WATERS Weekly FPY review (WW26 – 2018)

04 Jul 2018

WAT-441001280 (Ethernet Cable, supplier CMTi)

WAT-441001280 (Ethernet Cable, supplier CMTi)

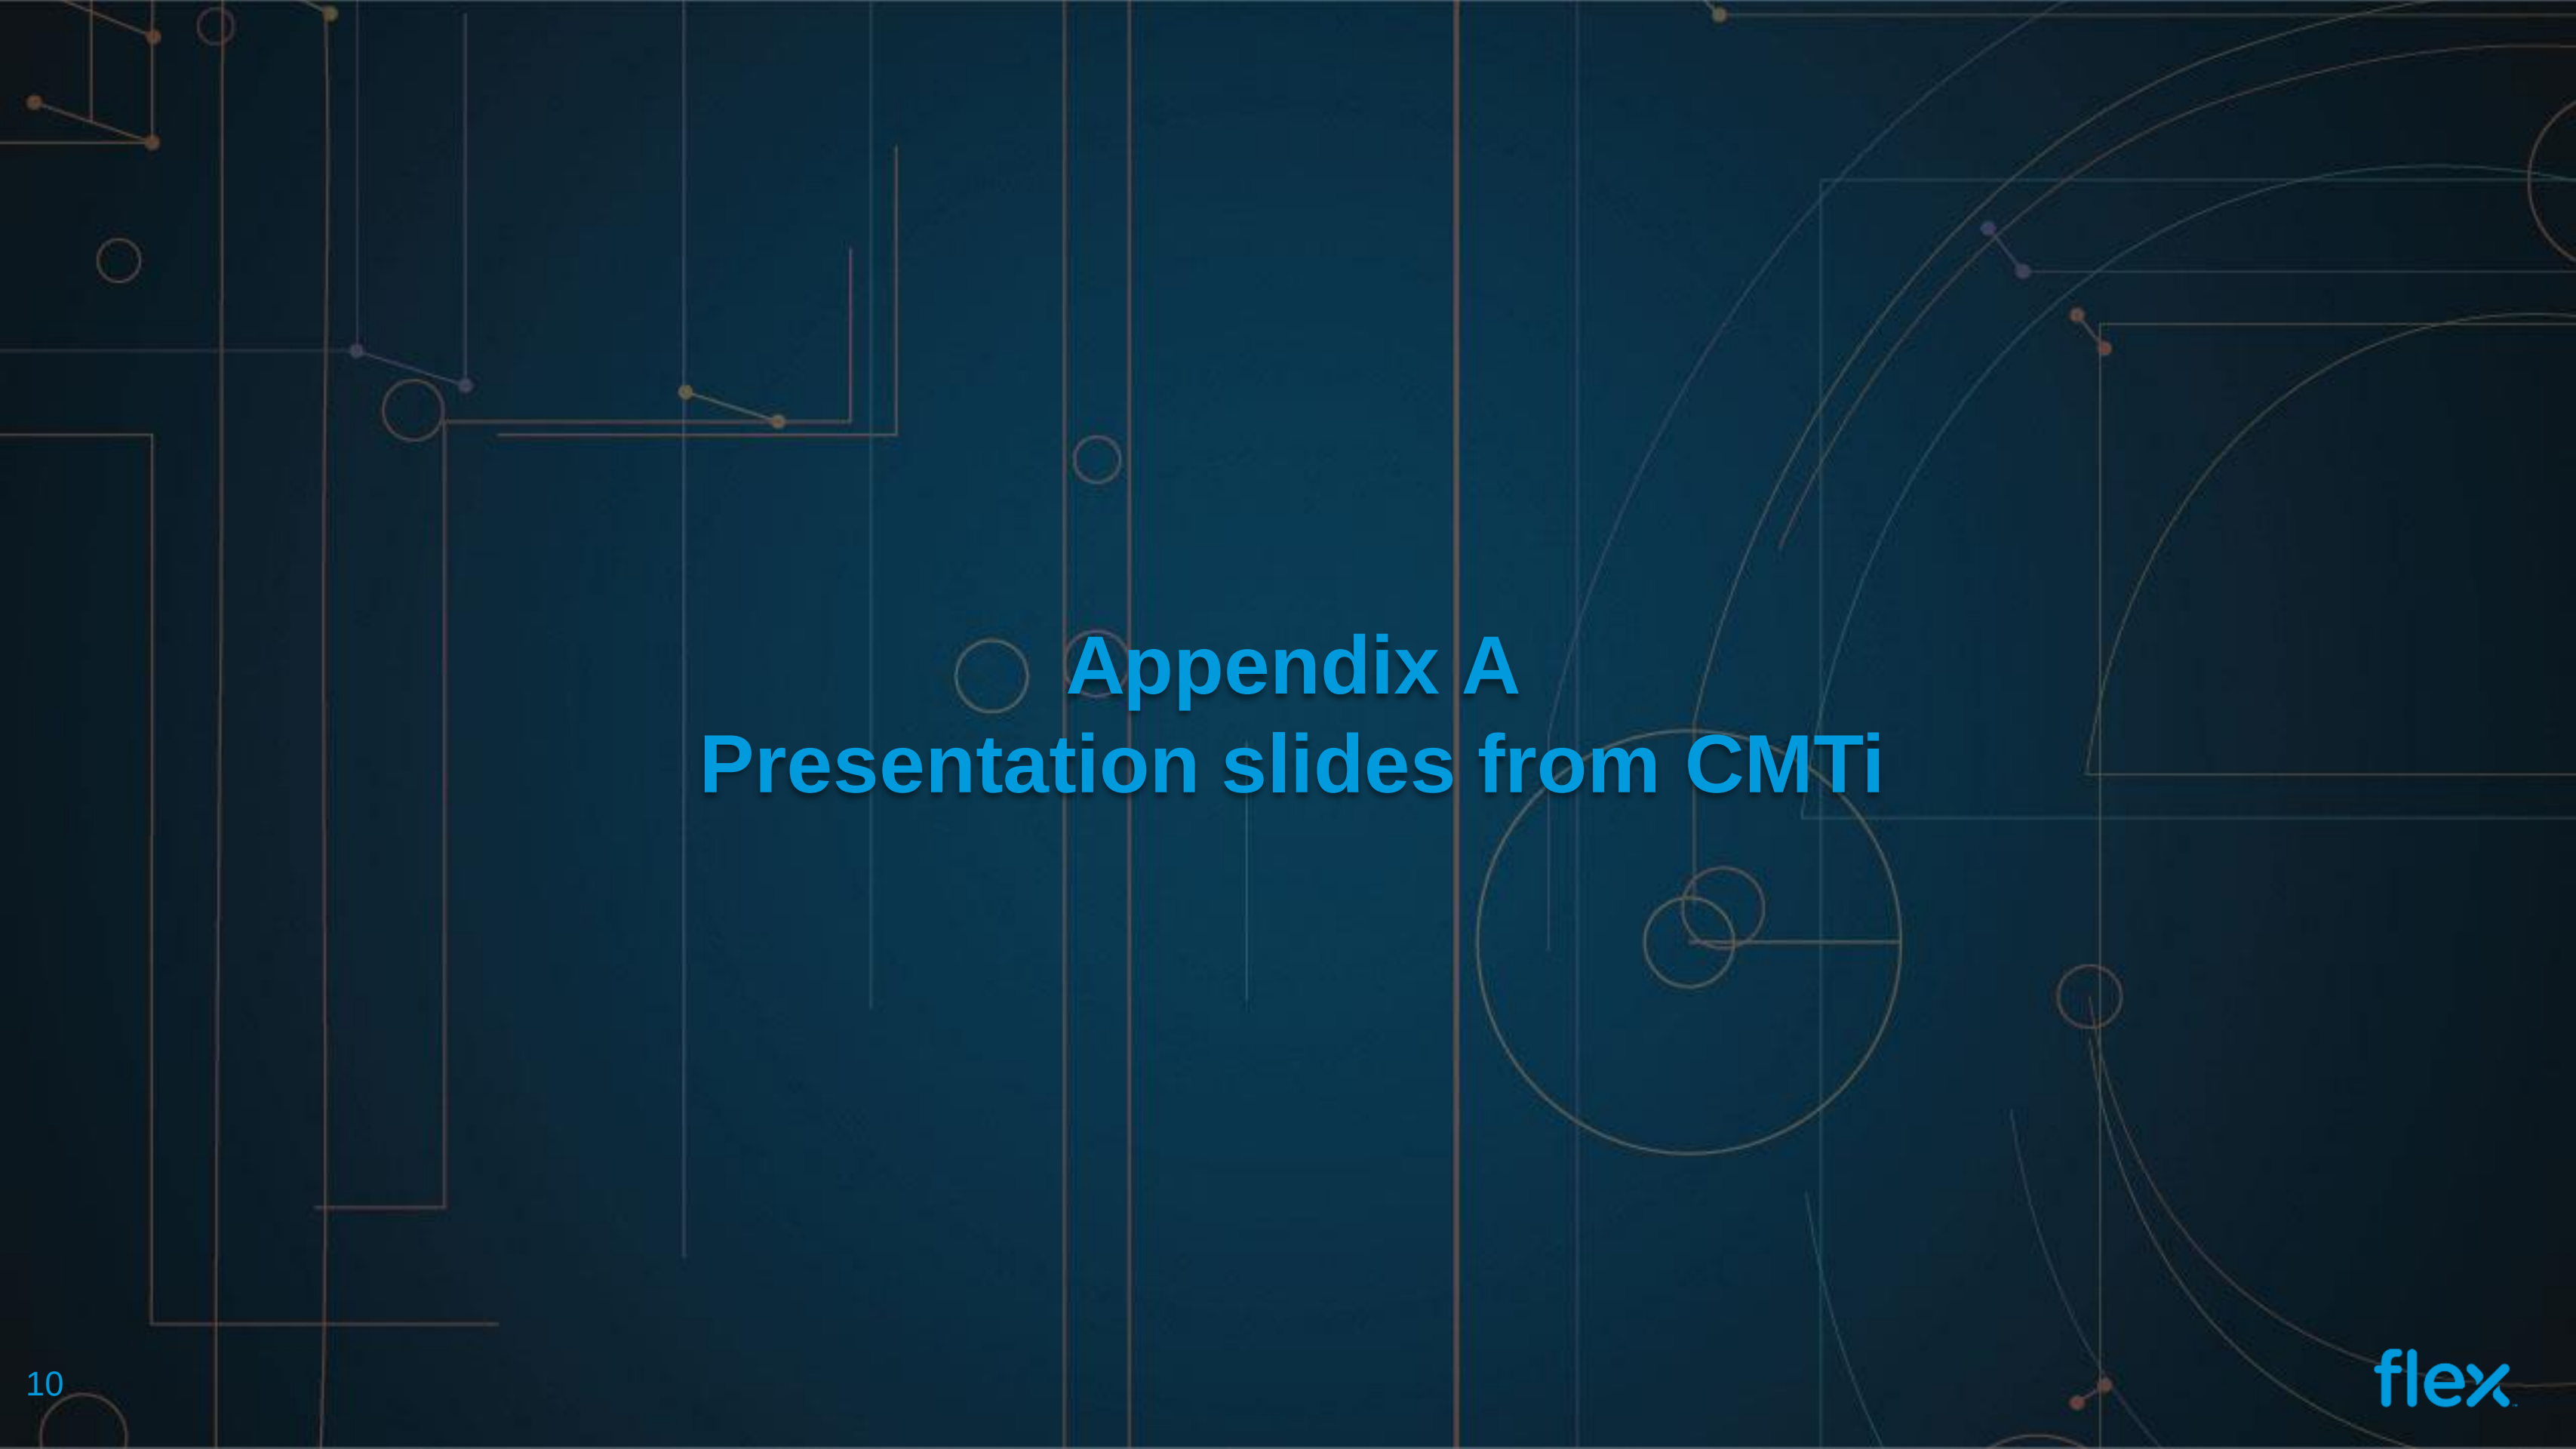
- CMTi reported that there is no failure reported at their outgoing since May 2017 (Qty tested: 9200 pcs)
- CMTi proposed to change the bending point.
- See Appendix A for more detail

Failed part

Raw part before bent

A – current bending point
B – proposed bending point

- Option A – if we were to proceed with this change, CMTi will have to raise a PCN (Process Change Notice). A small qty for trail is proposed before implementation in mass production.
- Option B – no change is needed. Based on the performance the failure rate is relatively low.

- There is no failure in Feb 2018 and Mar 2018 (Total > 600 instrument build)
- As the occurrence (Ethernet cable failing) is low and random, Flex does not recommend to go ahead with this change (Option A).
- Flex recommends to further monitor the yield and keeping this proposal as an option for future discussion.

IMPROVEMENT PROPOSAL

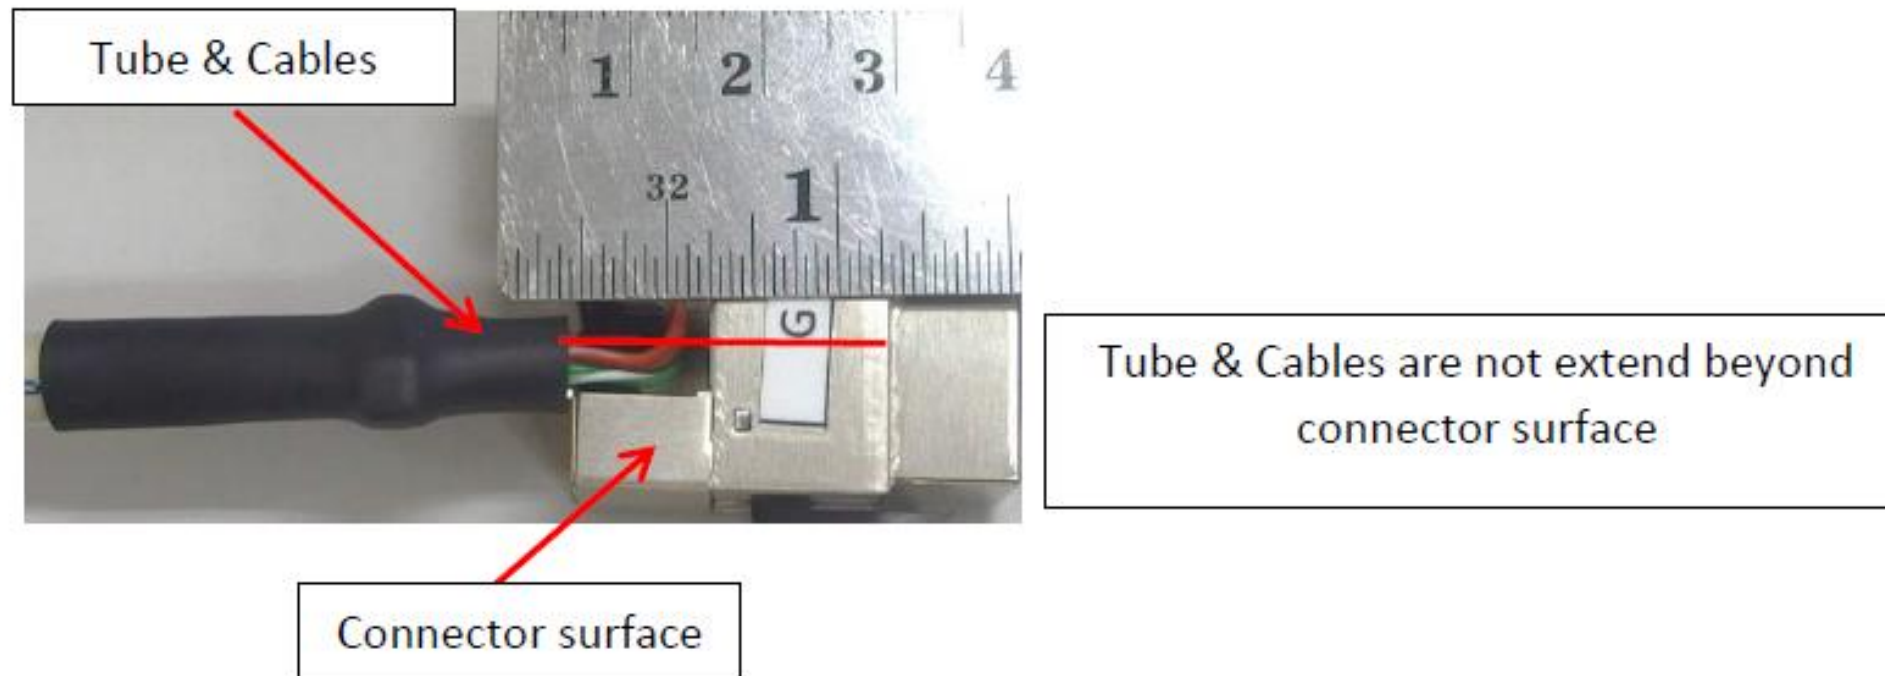
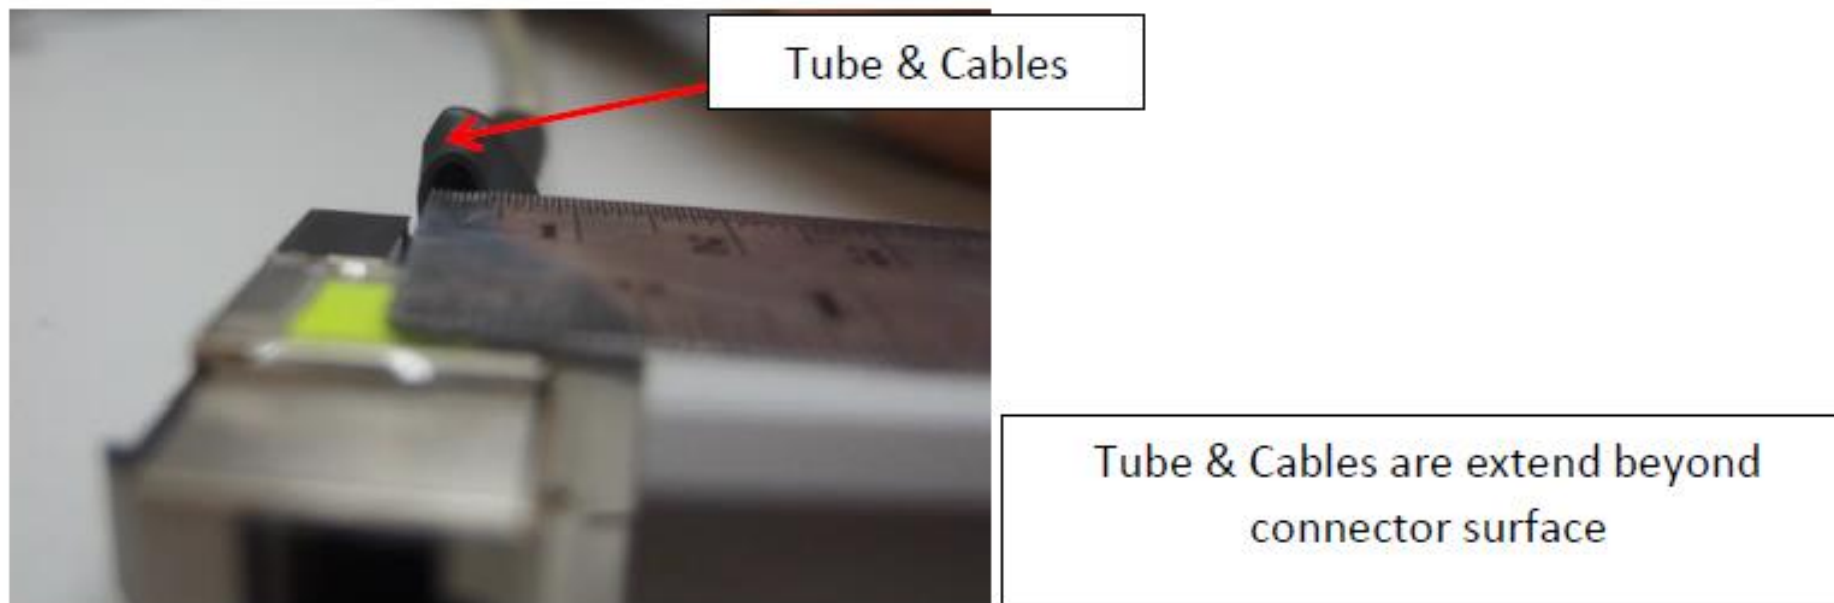
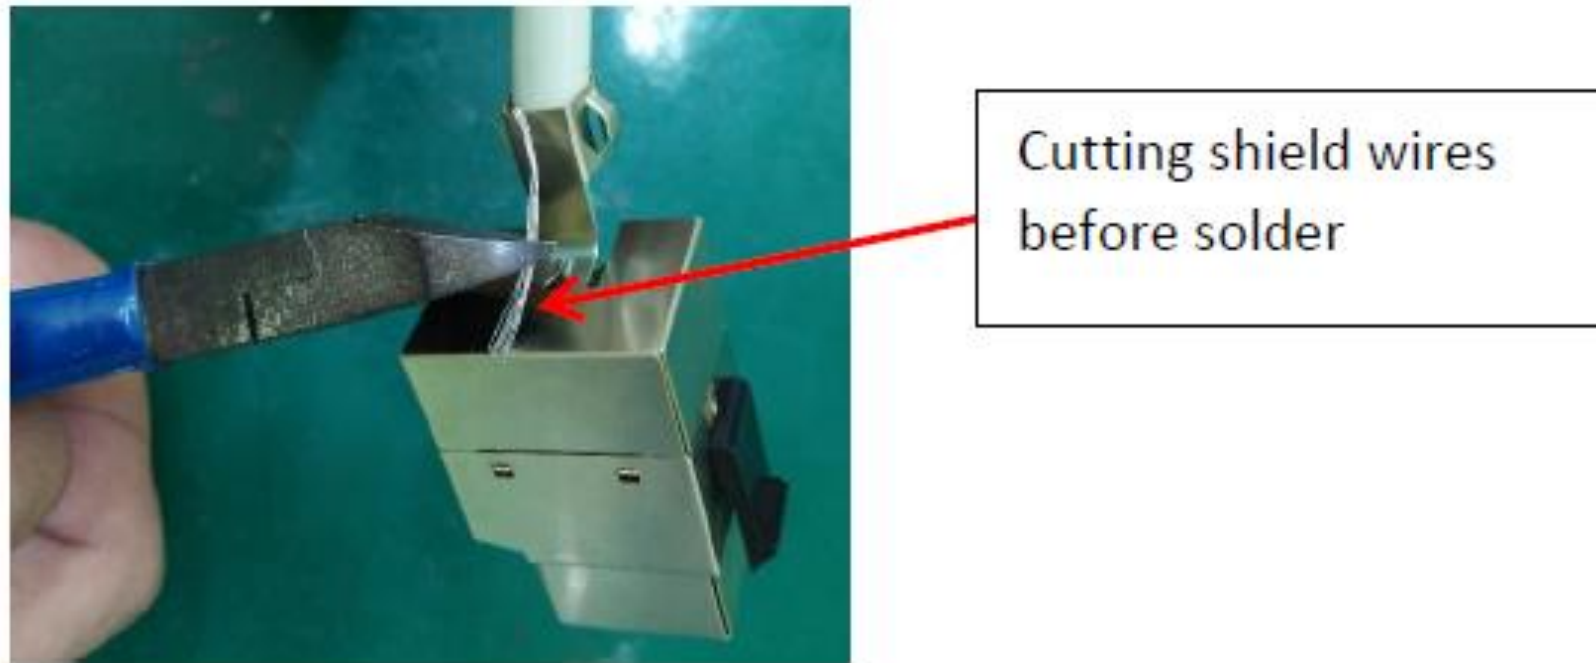
- ✓ Current bending method : Connector broken after 22 times bending
- ✓ Propose bending Method : Connector broken after 64 times bending

1. Propose bending method strength result is better than current bending method
2. Cable position of propose bending method is out of connector surface (refer to below picture for comparison)

3. There's additional cutting process for shield wire before solder to metal shield

4. Total Length of cables might sorter than current bending method. Therefore, we will conduct another simulation with actual product requirements when it's required.

- Propose bending method strength result is better than current bend method
- Cables & tube position are extend beyond connector surface might effect to form, fit
- There has additional cutting process for shield wire before solder
- Next simulation for total length of cables shall study if it's required.

Seal Pack Assembly 4M Review

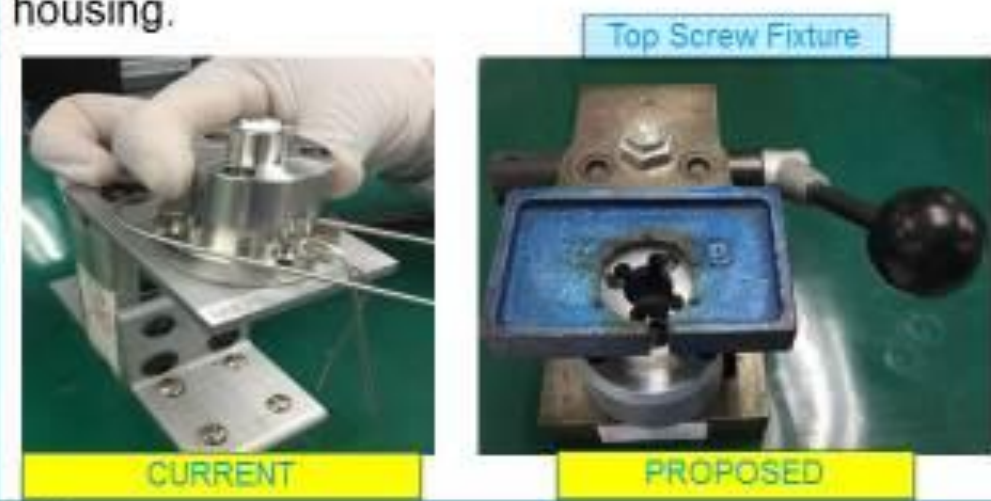
Category	Possible Causes	Verification	Possible cause (Y/ N)	Proposed Actions
Man	1) Untrained/ Uncertified operator	Verified trained/ certified operators are performing Sub Assy and Injector Test. No change in people observed.	N	NA

2) Operators not following the MPI defined steps.	Verified that operators performing the tasks as per Work instructions. No abnormality found.	N	NA
Method	Assembly method not repeatable and inconsistent	1)Assembly methods like Press operation, chemical wetting, screw tightening processes were reviewed and found ok. 2)It was suggested to put few more drops of methanol during press operation in-addition to current wetting of seals with methanol	N	Briefed Operator to pour methanol during both press operations in-addition current methanol wetting to seals.
Machine	No manufacturing Aids/Fixtures/Jigs.	1)Press fixtures were ok and no abnormality found. 2)Current Holding Fixture 999044874 does not allow to hold and press down Top, Middle and Bottle housing assembly into holding fixture before screwing assembly.	Y	Propose to purchase new fixture with top cover plate to hold and press down the Top, middle and bottom housing.  Top Screw Fixture CURRENT PROPOSED

Material	Part dimensions not meeting specs.	Parts dimensions were meeting specs as per respective IPC	N	NA
